Addendum #4

Project: GCSC Nursing Simulation Center

TYPICAL PATIENT BED

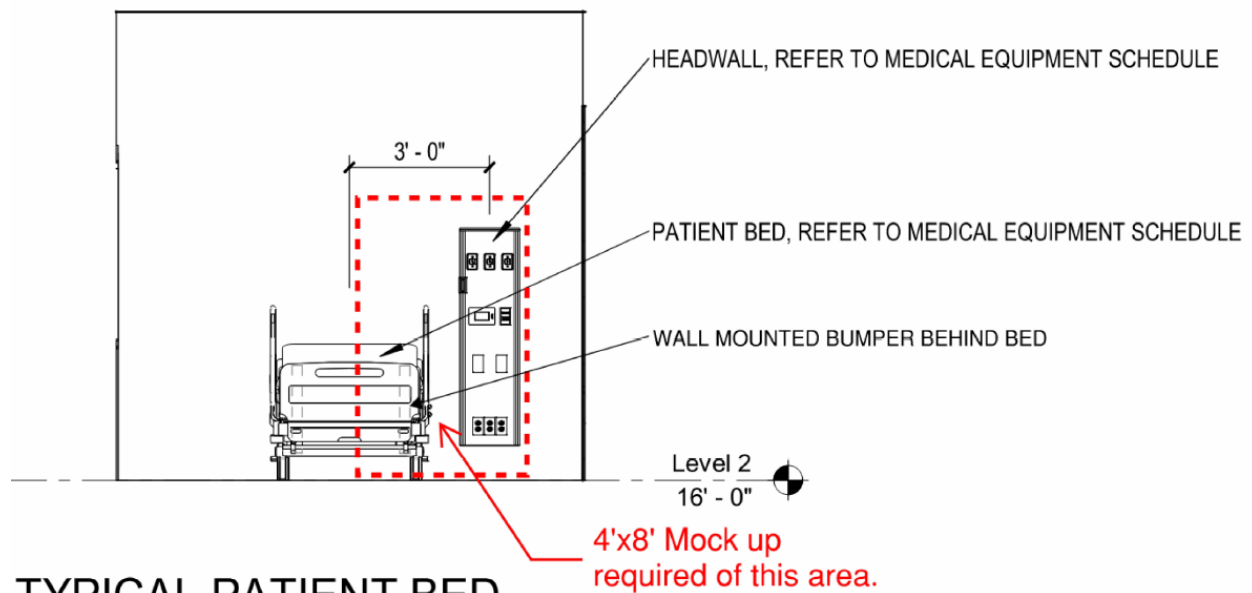
- What Mockups will be required? You answered, please ask this in an email, but likely Masonry, Eifs, Windows, Headwall, etc. **Please see attached.**

4'x8' Mock up
required of this area.
